# Car Stereo Service Bulletin

**Model:** MDX-U1

**No.** 295

**Subject:** Does Not Eject Discs

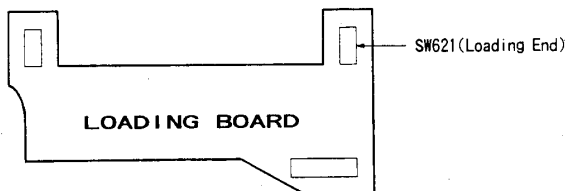
(61) The unit may not eject the disc.

**Solution:** Replace SW621 on the loading board, and the rack, with the improved parts as shown below.

Total number of the teeth is the original number less 3 teeth

Apply grease to first 3 teeth

REF	FORMER		NEW	
	DESCRIPTION	PART NUMBER	DESCRIPTION	PART NUMBER
SW621	SWITCH, PUSH (1 KEY)	1-572-467-31	SWITCH, PUSH (1 KEY)	1-572-467-61
209	RACK	3-384-442-01	RACK	3-384-442-11
